CITY OF PORTLAND

Permit Number: 031473

has permission to Construct - 3 story deck, add windows and doors and remodel 2nd & 3rd Fir Kitchens & Baths

City of Portland, Maine - Building or Use Permit Application

BOUNDARY SURVEY
 AT
 31 CLEEVES STREET, PORTLAND, MAINE
 MADE FOR
 GREGORY S. MARTIN
 31 CLEEVES STREET, PORTLAND, MAINE
OWEN HASKELL, INC.
 PROFESSIONAL LAND SURVEYORS
 16 CASCO ST., PORTLAND, ME 04101 (207) 774-0424

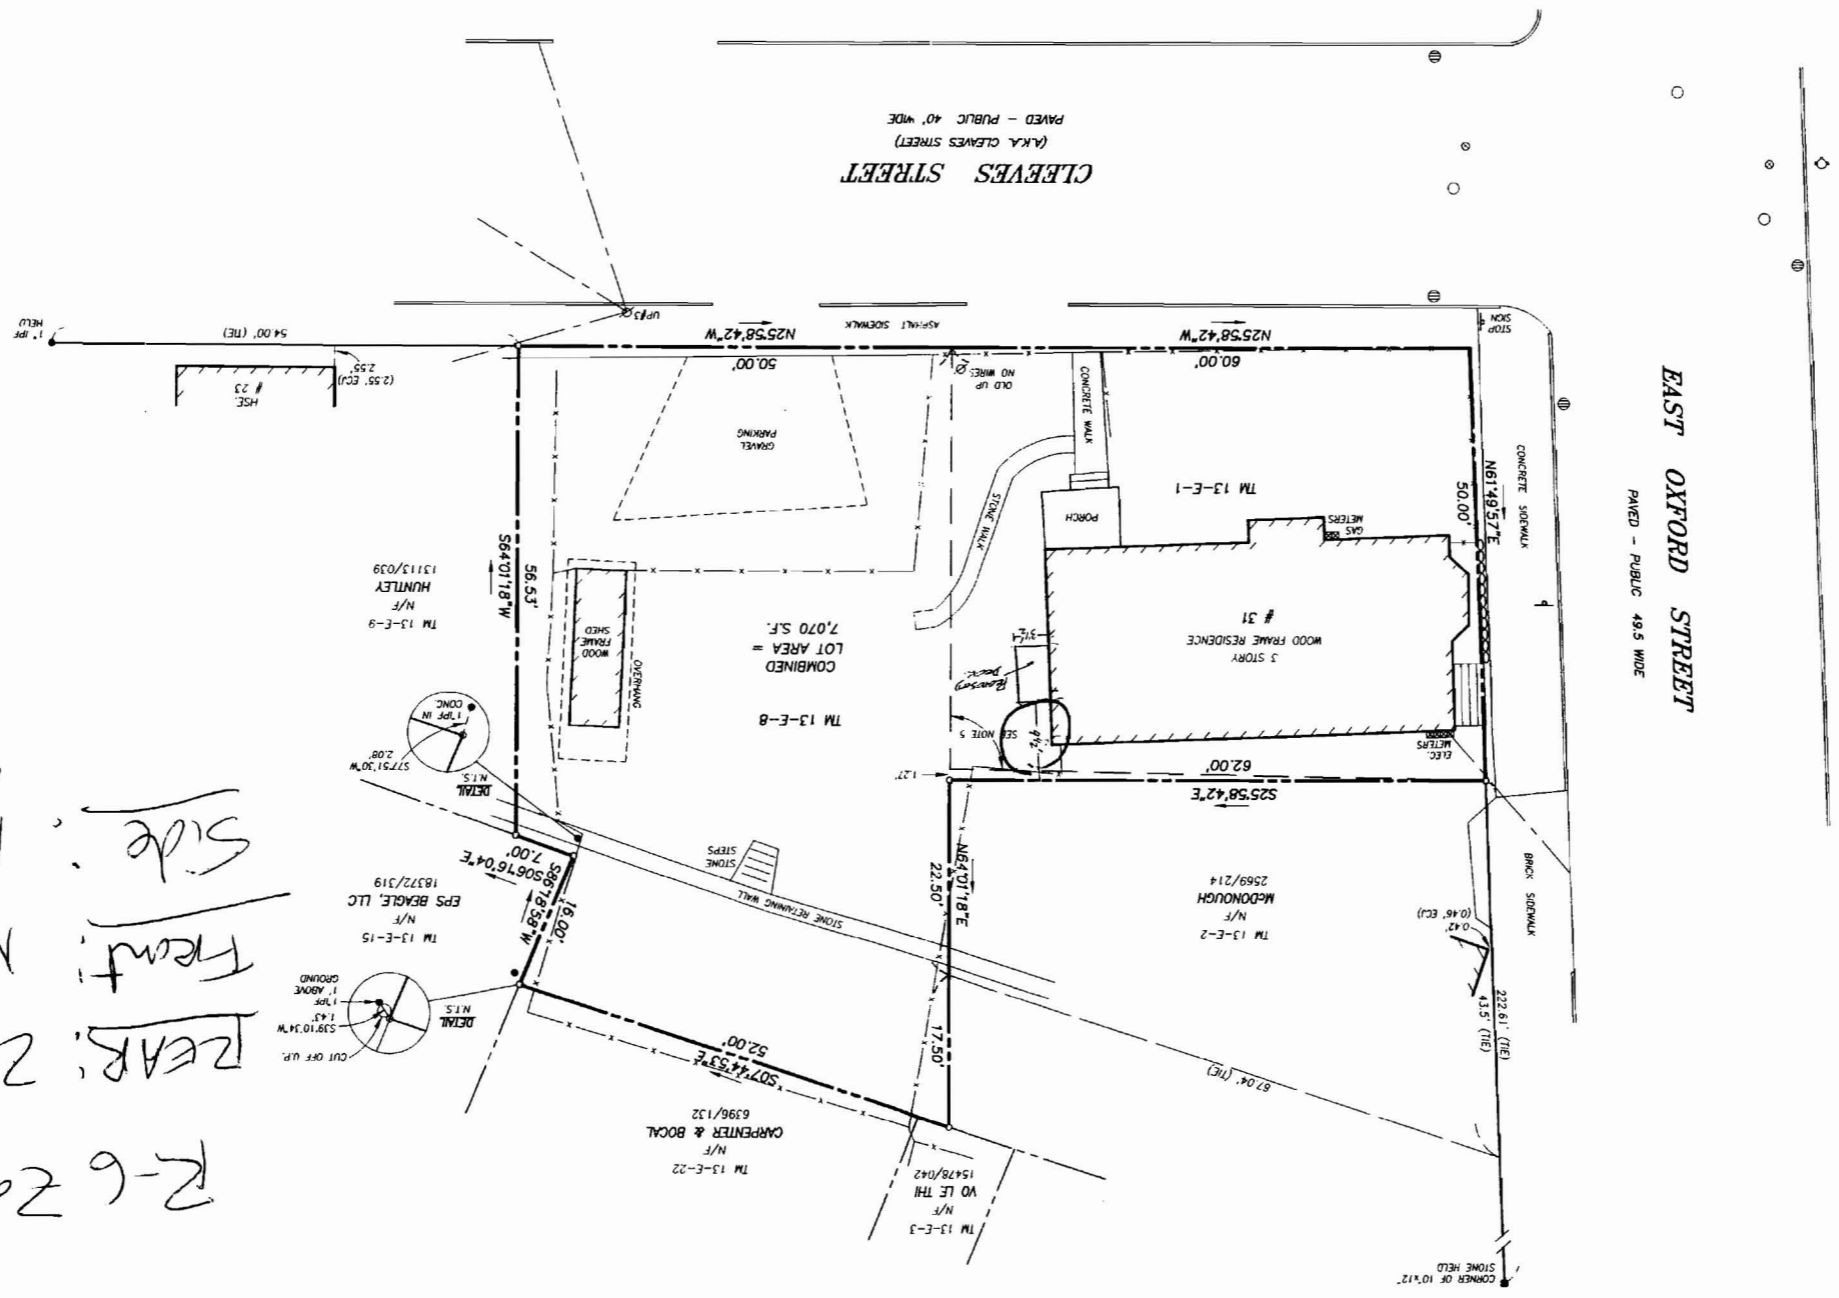
Handwritten notes:
 R-6 Zone
 REAR: 20' req - 20' + Shan
 Front: N/A
 Side: 10' normally req
 9.5' shown in 10' + Shan
 Walk Parise 14-433
 Interior Pipe & Windows
 Under location
